**Addendum #2**

**CHILD DEVELOPMENT LABORATORY**

**Southern University  
Baton Rouge, Louisiana 70813**

**Bid #9899      10:00 a.m.      October 13, 2005**

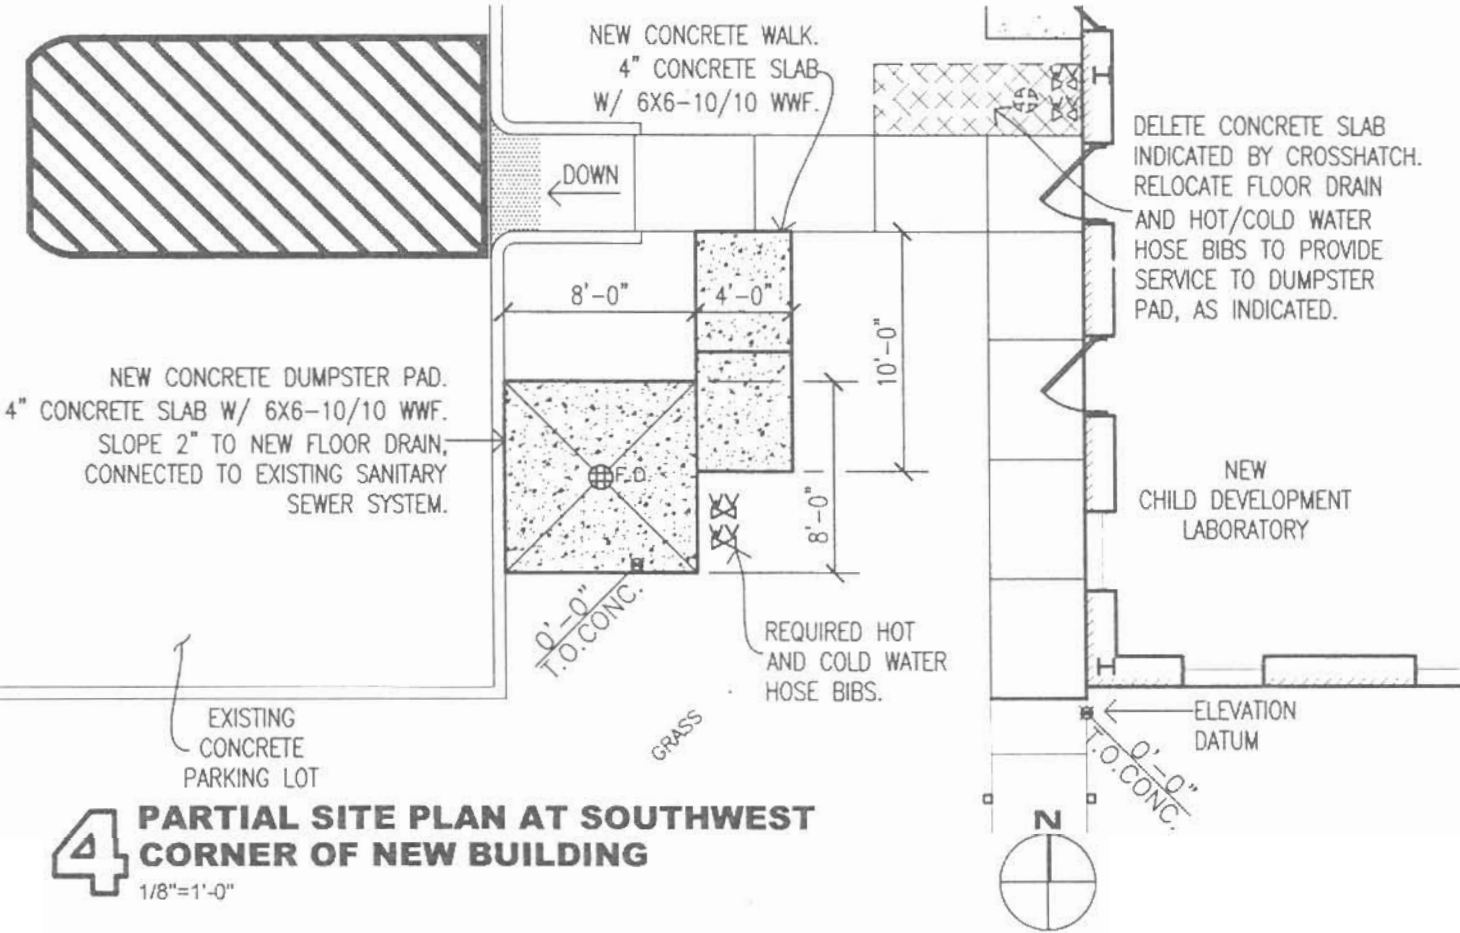
11. ITEM # 4, PARTIAL SITE PLAN AT SOUTHWEST CORNER OF BUILDING  
Change Drawing as shown:
